PIC16(L)F1826/1827 Family Silicon Errata and Data Sheet Clarification

The PIC16(L)F1826/1827 family devices that you have received conform functionally to the current Device Data Sheet (DS41391D), except for the anomalies described in this document.

FIGURE 1: INSTRUCTION CYCLE DELAY CALCULATION EXAMPLE

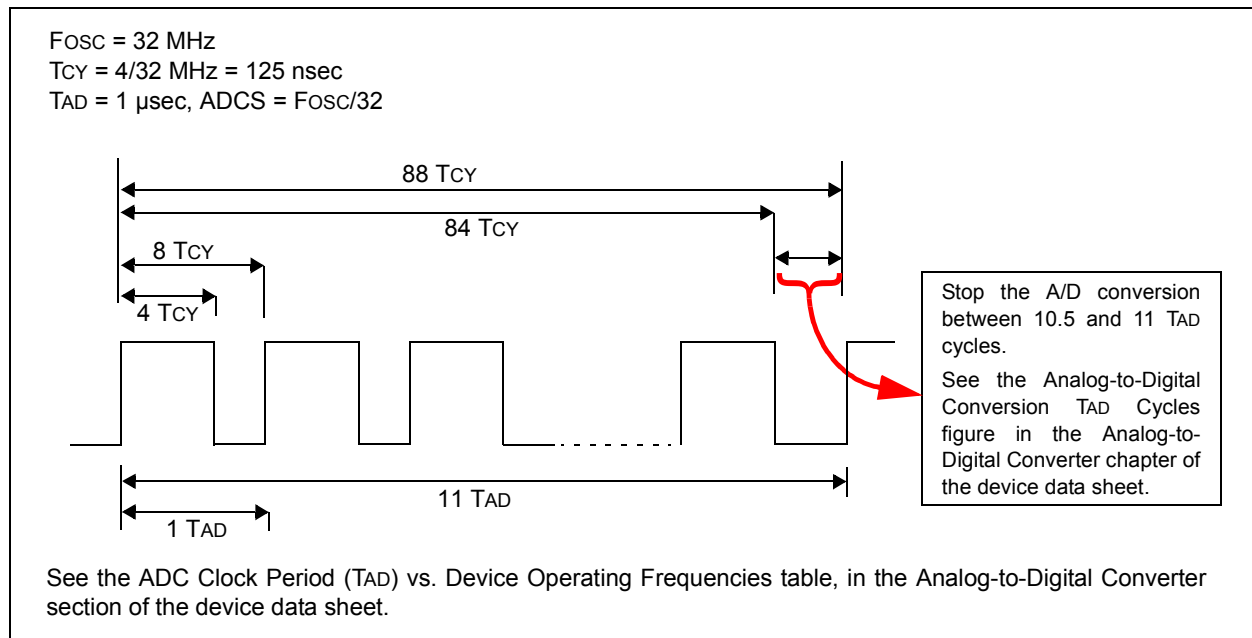
An ADC conversion may not complete under these conditions:

1. When F_{OSC} is greater than 8 MHz and it is the clock source used for the ADC converter.
2. The ADC is operating from its dedicated internal FRC oscillator and the device is not in Sleep mode (any F_{OSC} frequency).

When this occurs, the ADC Interrupt Flag (ADIF) does not get set, the GO/DONE bit does not get cleared, and the conversion result does not get loaded into the ADRESH and ADRESL result registers.

Method 3: This method is provided if the application cannot use Sleep mode and requires continuous operation at frequencies above 8 MHz. This method requires early termination of an ADC conversion. Provide a fixed time delay in software to stop the A-to-D conversion manually, after all ten bits are converted, but before the conversion would complete automatically. The conversion is stopped by clearing the GO/DONE bit in software. The GO/DONE bit must be cleared during the last $\frac{1}{2}$ TAD cycle, before the conversion would have completed automatically. Refer to Figure 1 for details.

In Figure 1, 88 instruction cycles (Tcy) will be required to complete the full conversion. Each TAD cycle consists of eight Tcy periods. A fixed delay is provided to stop the A/D conversion after 86 instruction cycles and terminate the conversion at the correct time as shown in the figure above.

Note: The exact delay time will depend on the TAD divisor (ADCS) selection. The Tcy counts shown in the timing diagram above apply to this example only. Refer to [Table 3](#) for the required delay counts for other configurations.
